YANKEE ATOMIC ELECTRIC COMPANY

Subject: Yankee Rowe Core XII Rod Ejection Analysis

ATTACHMENT A TO SUPPLEMENT NO. 9

OF PROPOSED CHANGE NO. 125

Figure
7.8-1

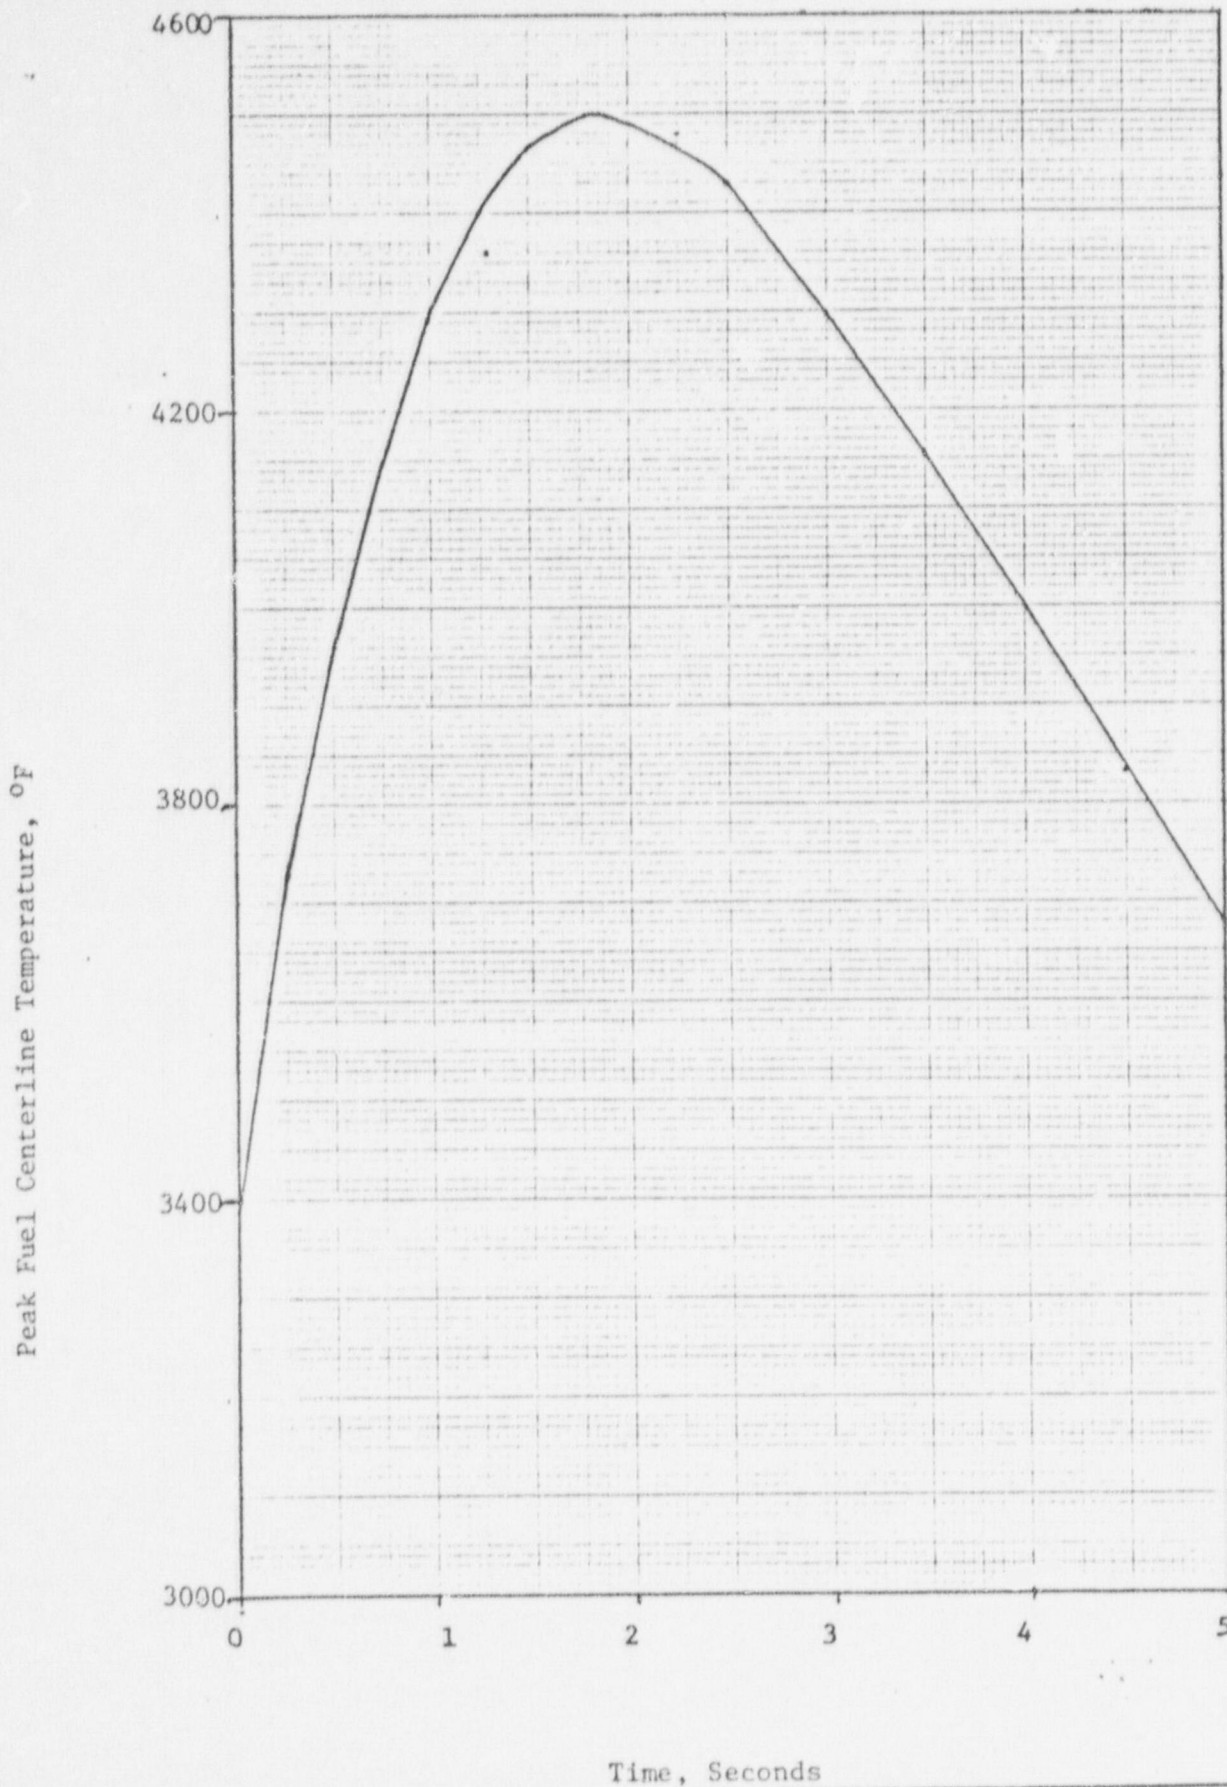
Tables 7.8-1 through 7.8-4 and Figures 7.8-1 through 7.8-4 present the initial conditions and results for the full power and zero power cases.
